Westinghouse
Electric Corporation

NTD-NRC-94-4087
DCP/NRC0024
Docket No.: STN-52-003

SUBJECT: WESTINGHOUSE RESPONSES TO NRC REQUESTS FOR ADDITIONAL
INFORMATION ON THE AP600

NTD-NRC-94-4087
ATTACHMENT A
AP600 RAI RESPONSES
SUBMITTED MARCH 24, 1994

Figure 3.8.2-7 (Sheet 1 of 2)
Location of Containment Seal

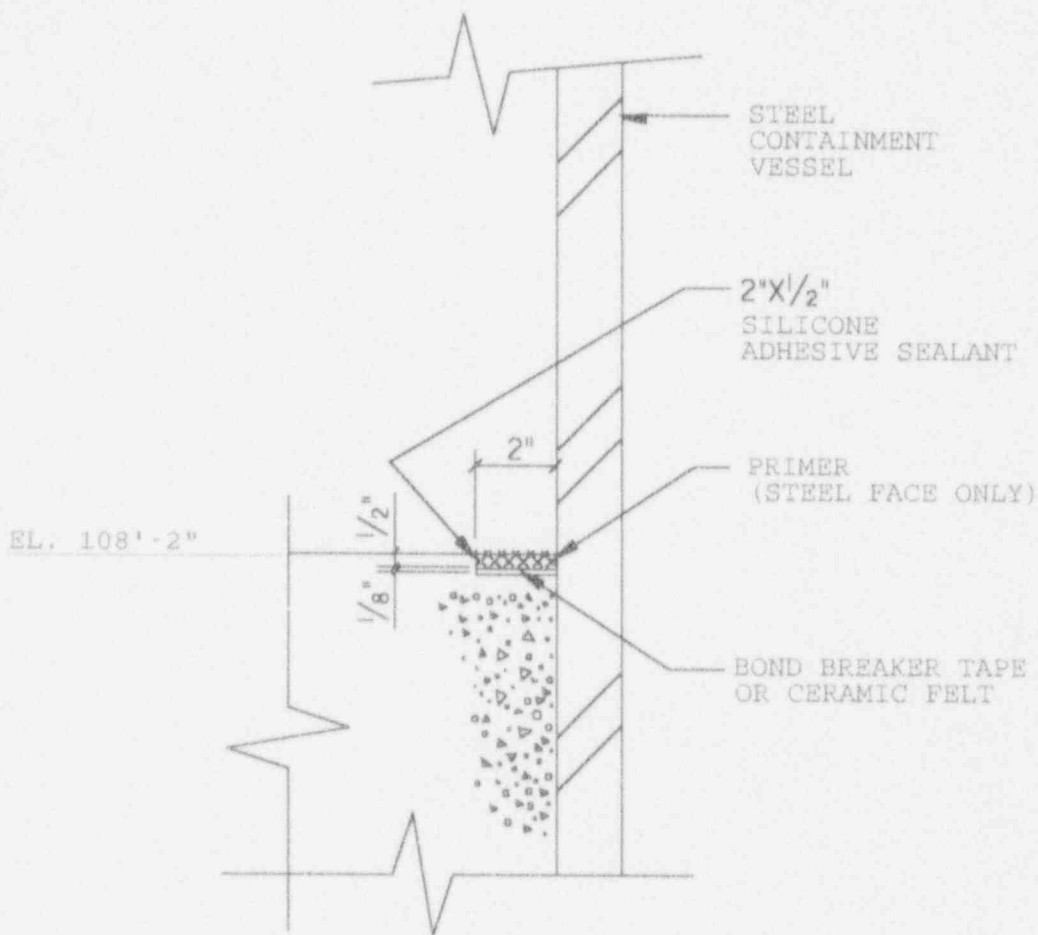
At the transition region between the free-standing part and the encased portion of the steel containment, seals are provided at the top of the concrete at elevation 108 ft inside the vessel and at elevation 100 ft outside the vessel so that moisture is not trapped next to the steel vessel just below the top of concrete. The seal on the inside accommodates radial growth of the vessel due to pressurization and heatup. The staff is concerned about the mechanical properties of this seal material and the stress conditions and buckling potential of the steel containment in this region. No information is provided in the SSAR concerning (1) composition of the seal material, (2) the method used to obtain these material properties, (3) the uncertainties associated with these material properties, (4) the accessibility to perform periodic inspection, and (5) the behavior under the severe accident conditions. Address the issues associated with (1) the uncertainty of the mechanical properties of this seal material and the environmental qualification as well as age related degradation management for the proposed 60-year design life for this seal material, and (2) the measures to be implemented to prevent collection of moisture in the transition region (Section 3.8.2 of the SSAR).

To prevent collection of moisture in the transition region between the free-standing and the encased portion of the steel containment, at Elevation 108'-2" inside the vessel and at Elevation 100'-0" outside the vessel, the following measures are provided:

- The concrete curb inside the containment vessel at Elevation 108'-2" and the concrete slab outside the containment vessel at Elevation 100' are sloped away from the steel containment vessel to prevent water ponding adjacent to the vessel.
- Silicone seals are provided at these two locations. The configuration of the silicone seal is shown in the attached Figure 3.8.2-7. These seals are not required to function under design basis or SSE conditions. They are provided to enhance corrosion protection of the vessel and are designed for the transient conditions anticipated during normal operation.

Add the attached Figure 3.8.2-7, sheets 1 and 2, into Section 3.8.2.

Figure 220.32-1 Comparison of Capacity Reduction Factors for Tests with Code Case N-284

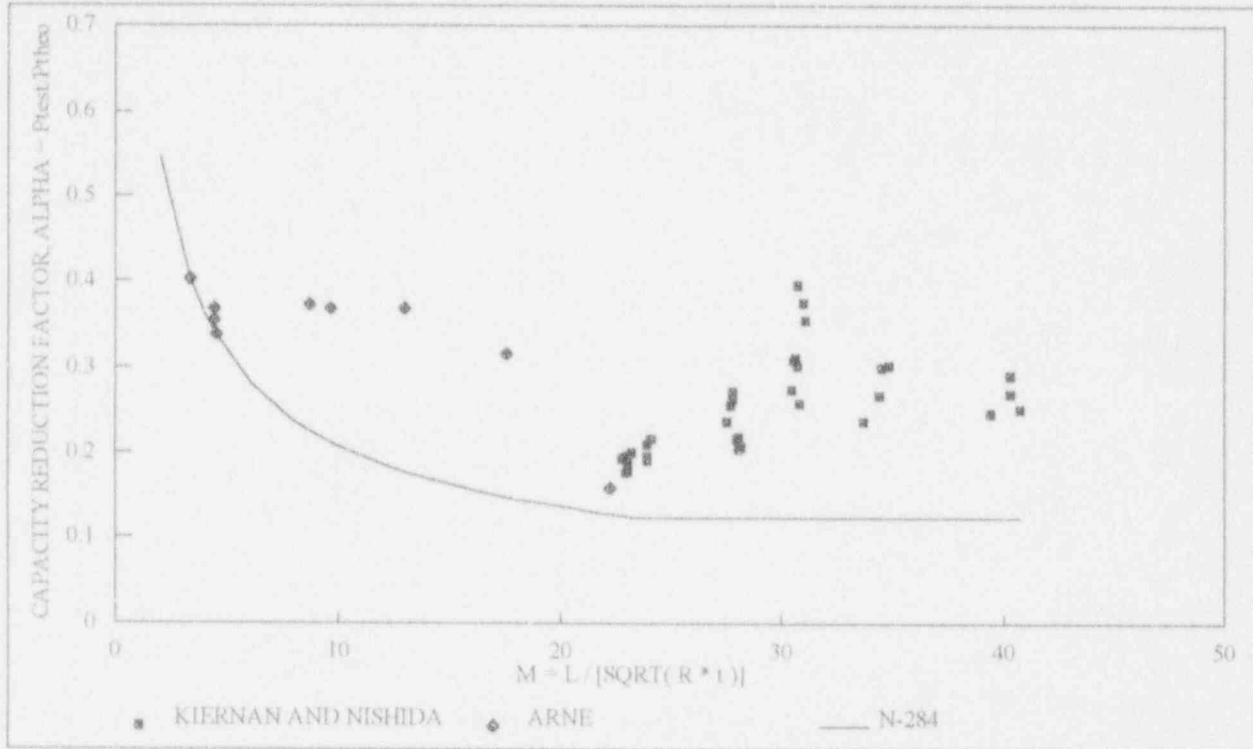
Westinghouse estimates critical buckling pressures for equipment hatches as 196 psig for a 22-foot-diameter hatch and 161 psig for a 16-foot-diameter hatch. The corresponding ASME Level C Service Limits are 117 psig and 96 psig using the Code Case N-284, respectively. From Figure 3.8.2-2, the equipment hatch covers appear convex to the center line of the containment. Therefore, the use of the Code Case N-284 (i.e., the factor of safety of 1.67 for the Level C Service Limit) is not acceptable because the internal pressure of the containment acts as the external pressure to the spherical cap covers and subjects the cap covers to compression. In the case of external pressure, ASME NE-3222 (i.e., the factor of safety of 2.5 for the Level C Service Limit) should be used for the compressive stresses. Note (1) in Table 3.8.2-2 should be revised to reflect the factor of safety of 2.5, or acceptable justification should be provided for not doing so (Section 3.8.2 of the SSAR).

ASME Code Case N-284 was developed by the code committee based on detailed review and evaluation of test data. Figure 220.32-1 shows test results from references 220.32-1 and 220.32-2 for fabricated steel hemispherical shells and spherical segments. The ratio of test buckling stress to theoretical buckling stress (α) is shown as a function of the non-dimensional unsupported length along the shell ($M = L_i/\sqrt{Rt}$, where L_i is the unsupported length along the spherical shell, R is the radius of the shell and t is the thickness of the shell). The lower bound curve to these data points, as shown in the figure, is used in Code Case N-284. For the AP600 16 foot diameter equipment hatch, $M = 14.5$, and the capacity reduction factor, corresponding to α in the figure, is 0.167. The stresses in the hatch cover are well below yield and the plasticity reduction factor is unity. The test data for shell lengths of 10 to 20 show capacities significantly above those of the Code Case. The capacity of the hatch covers, as calculated by the ASME Code Case, corresponds to the lower bound of the test data. As a result the 1.67 factor of safety specified in paragraph 1400 of the ASME Code Case is considered appropriate for calculating the Service Level C pressure capacities of the hatch covers.

Figure 3.7.1-17
Shear Wave Velocity of Design Soil Profiles

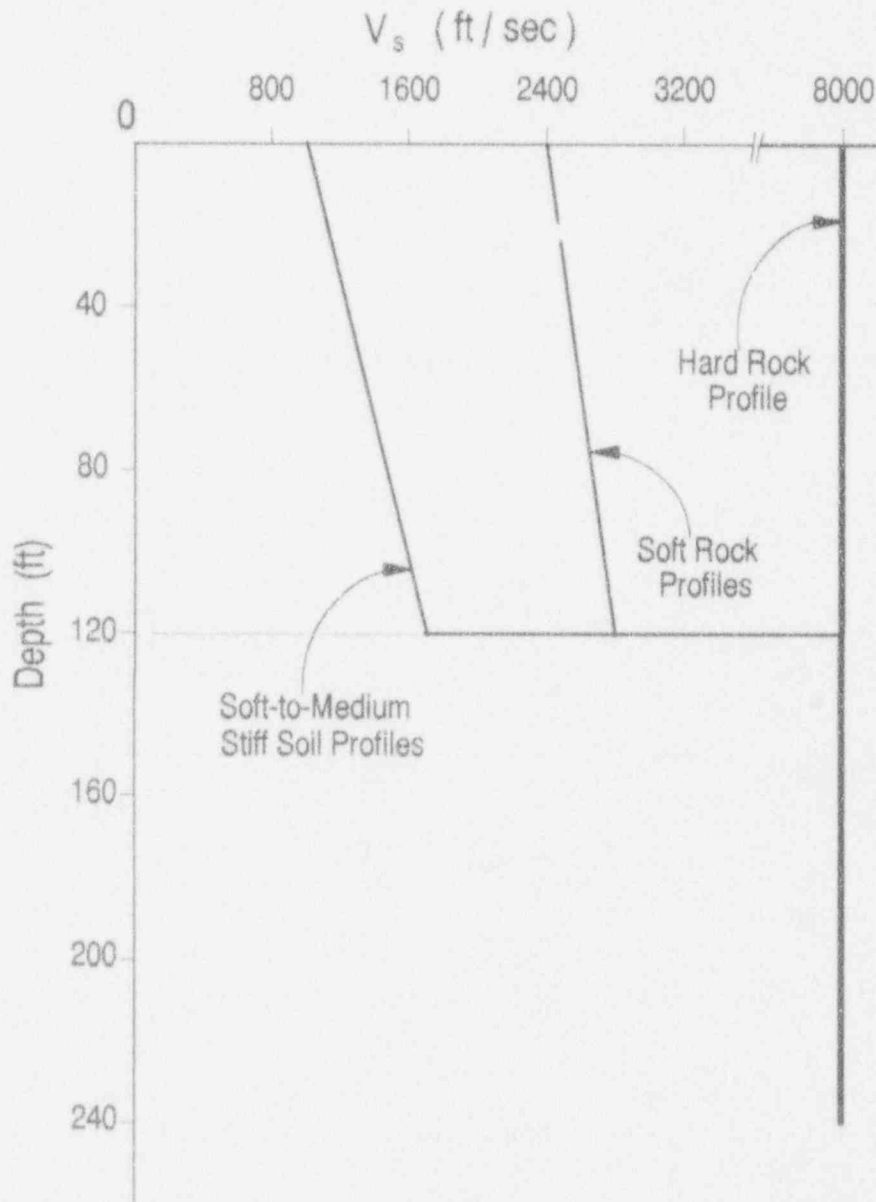
- a. What is the shear wave velocity profile for the base rock?
- b. Because the base rock is at the depth of 120 feet, how significant will it be to specify the shear wave velocity profile from the depth of 120 feet to 240 feet for both soft-rock and soft-to-medium stiff soil sites? Provide such a profile or provide justification for not doing so.
- c. Because the location of the base rock is not shown in Figure 2A-7 of SSAR, provide a complete plot for the shear wave velocity profile for hard-rock, soft-rock and soft-to-medium stiff soil sites.

- c. The shear wave velocity profile for the design soil profiles, hard-rock, soft rock and soft-to-medium stiff soil sites, with variation of depth to base rock, are shown in the attached Figure 3.7.1-17.

Add the attached Figure 3.7.1-17 to Section 3.7.1

The shear wave velocity profile for the design soil profiles, with variation of depth to base rock, is shown in Figure 3.7.1-17.
